SPAULDING REHABILITATION HOSPITAL
BUILDING ADDITION
AND
THERAPEUTIC/RECREATIONAL PIER

FINAL ENVIRONMENTAL IMPACT REPORT
EOEA NO. 7317

June 15, 1989

FIGURE 3-4
PROPOSED RECREATIONAL PIER

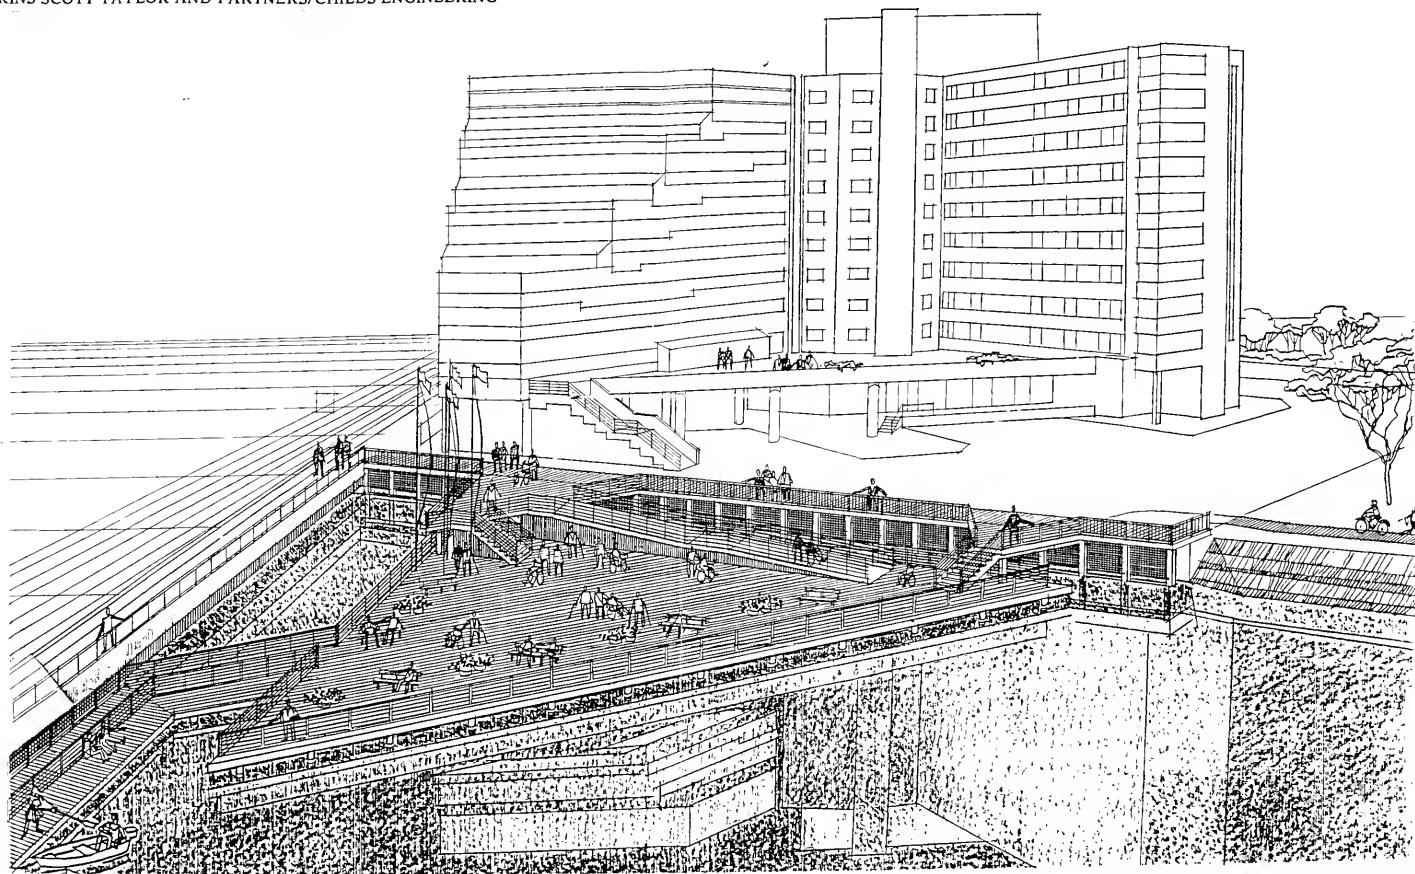
Comment #2.02 – Recreational Pier Design

Comment #5.02 – Drawings

There needs to be further discussion between the MDC, DEQE, and hospital officials concerning final design of the pier as agreed to by all parties. The proponent should provide necessary drawings.

A recreational pier design, based on Scheme J, is described in detail in Section 3.5 of the Final EIR (Scheme J was a preliminary drawing of the pier prepared by Hoskins Scott Taylor and Partners, Inc.). The currently proposed design (a 7,000 square foot triangle plus walkway and promontory) represents a consensus on the size, shape and location of the pier as approved by all interested agencies through the design development process described in Section 3.3. Additional design details related to the promontory, railings, stair and ramp placement, benches, planters, lighting, and signage will be finalized in continuing discussions prior to the issuance of a Chapter 91 Waterways License.

Perspective and plan drawings of the proposed pier have been prepared by HST and Partners architects with Childs Engineering. These are shown in Figures 3-3 and 3-4.

FIGURE 3-5
SITE PLAN OF PROPOSED RECREATIONAL PIER

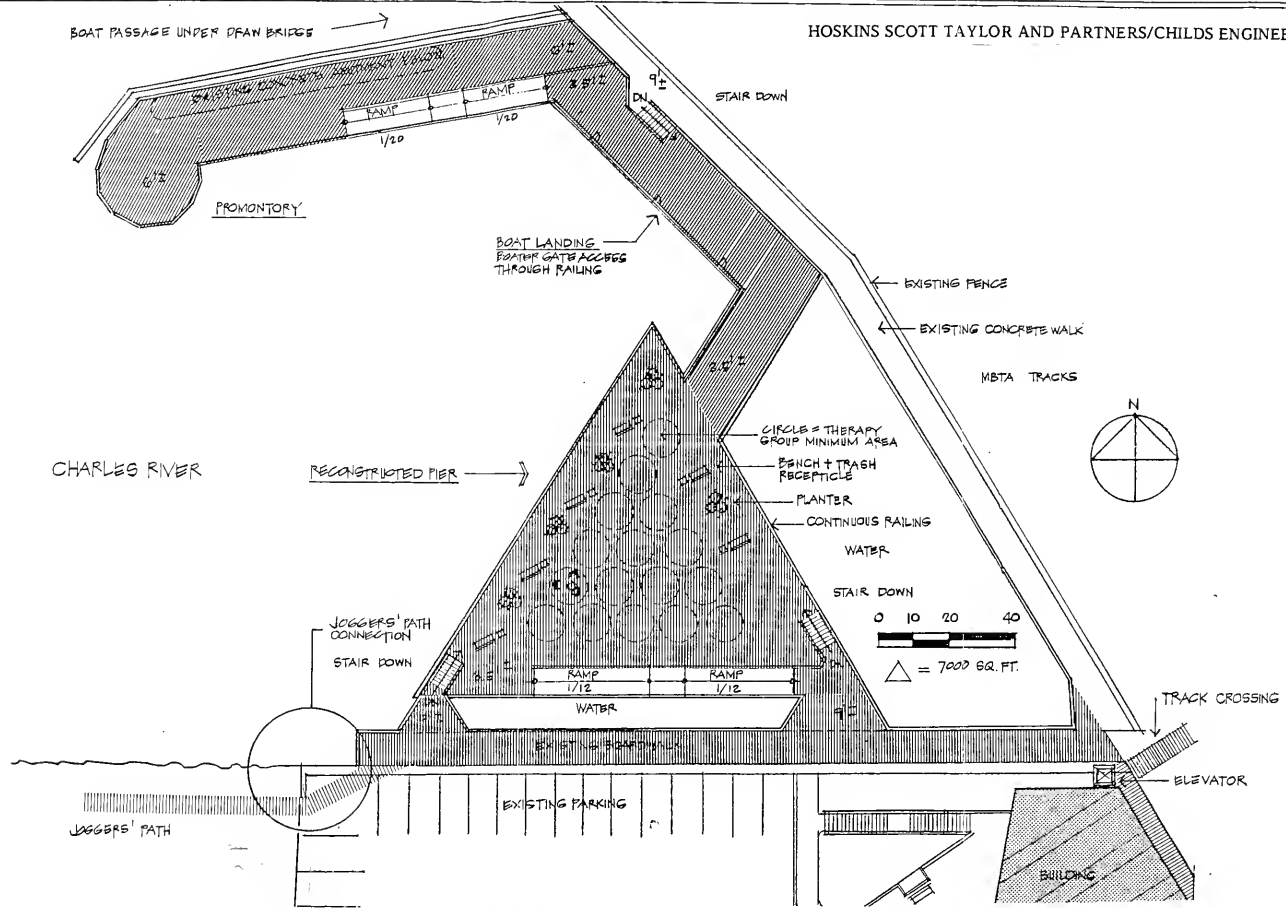
Comment #2.03 – Transient Boat Dockage and Fishing

Comment #4.04 – Boat Landing

.01 The recreational pier could provide additional opportunity for much needed transient boat docking, thereby promoting land and water connections. We encourage the provision of these docking opportunities along the promontory rather than along the western edge of the main pier in order to maintain that area for fishing and viewing.

Uses of the proposed recreational pier have been expanded to include transient docking for canoes and other small boats. This landing will be provided along the 3.5-foot walkway to the promontory, as shown in Figure 3-5. This will maintain the western edge of the pier for fishing and viewing. Ladders will be provided to facilitate boater access to

Uses of the proposed recreational pier have been expanded to include transient docking for canoes and other small boats. This landing will be provided along the 3.5-foot walkway to the promontory, as shown in Figure 3-5. This will maintain the western edge

FIGURE 3-6
PEDESTRIAN ACCESS - OPTION 1

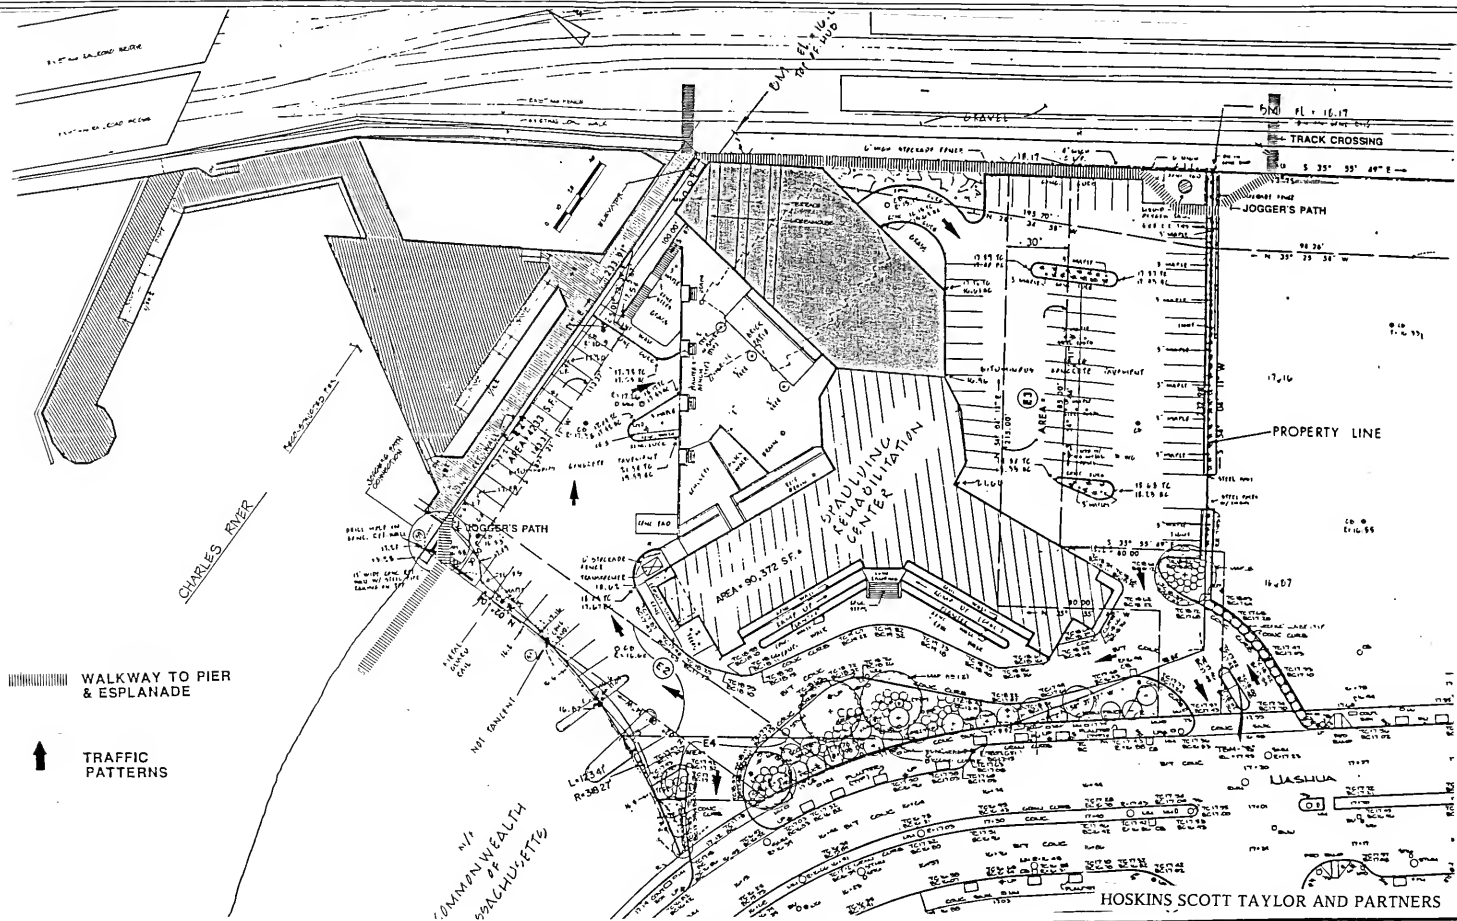
Comment #6.03 – Alternative Pedestrian Access Design

SRH has explored the pedestrian walkway suggested by the BRA and agrees that it is the most direct, safe, and pleasant route to the North Station area. The advantages of this alternative, described as Option 1 in this Final EIR, are discussed and illustrated in detail in Section 3.6.
